**ADDENDUM NUMBER 2**

<u>PROJECT</u>	<u>BIDS DUE</u>
Charter Township of Union CWSRF Project 5913-01 2026 Wastewater Treatment Facility Upgrades GFA Project No: 25357	Date: June 23, 2026 Time: 10:00 AM Location: Charter Township of Union 5228 South Isabella Rd Mt Pleasant, MI 48858

**SCREEN LIFT SYSTEM DETAIL**

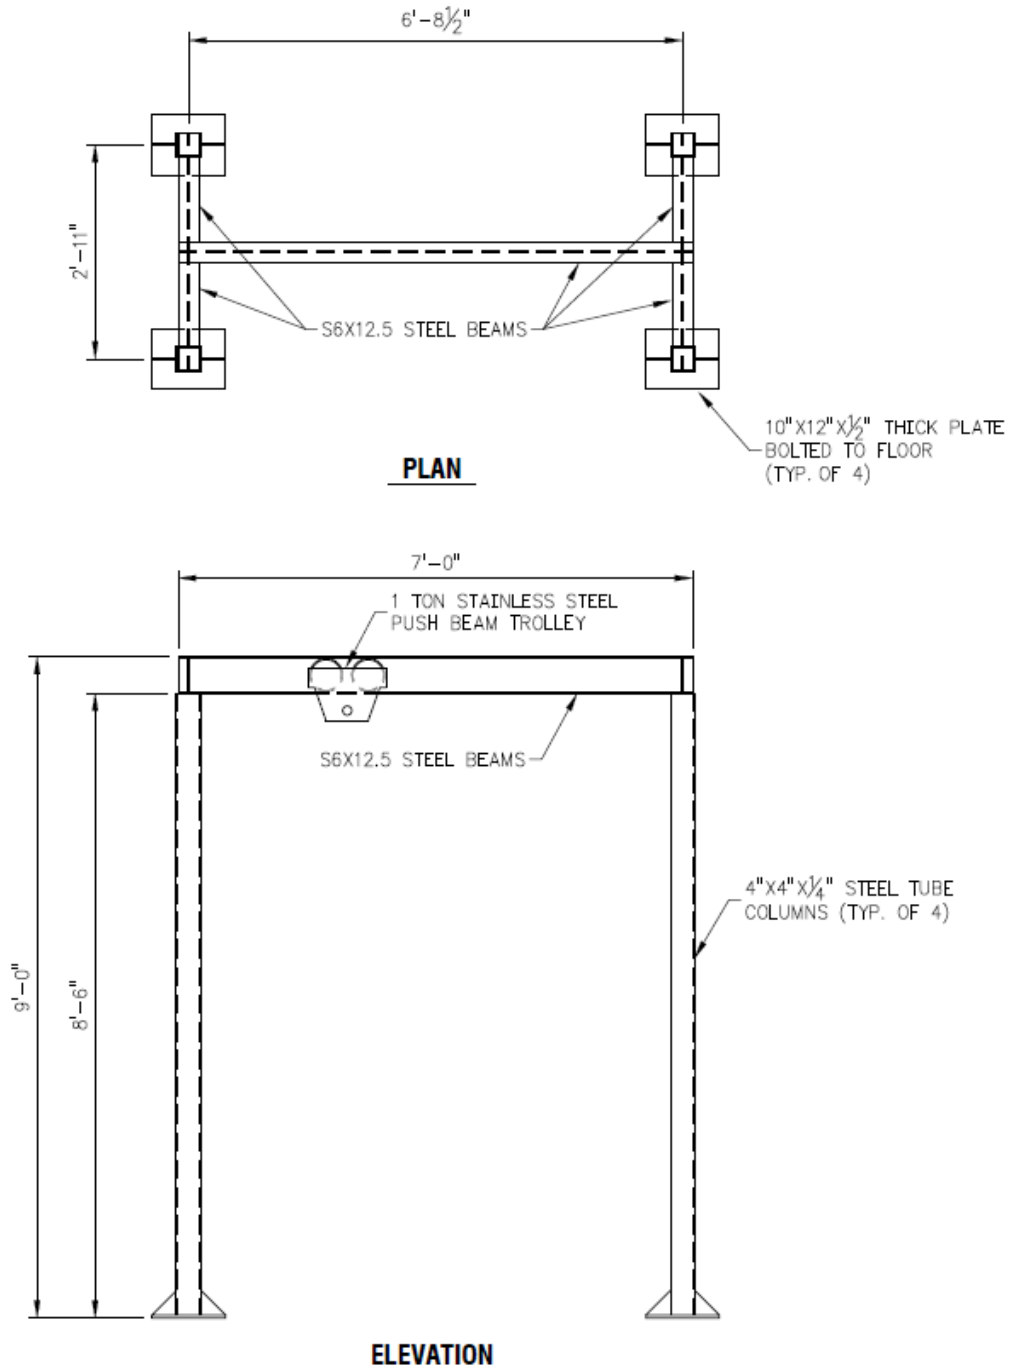
2. Sheets S2.2 and S2.3- any reference to bitumastic coating to be stricken and replaced with CIM 1000.
3. Sheet PM2.2 Headworks Building Proposed Mechanical Plan: The following detail shall be incorporated into the drawing sheet as reflected in the bid documents for Permanent Trolley System – Bid Item No. 32. Location of system shall be coordinated with Township and Engineer. Details are provided for bidding purposes. Contractor shall be responsible for verifying existing site conditions for compatibility and shall provide any proposed modifications for review and approval prior to fabricating.
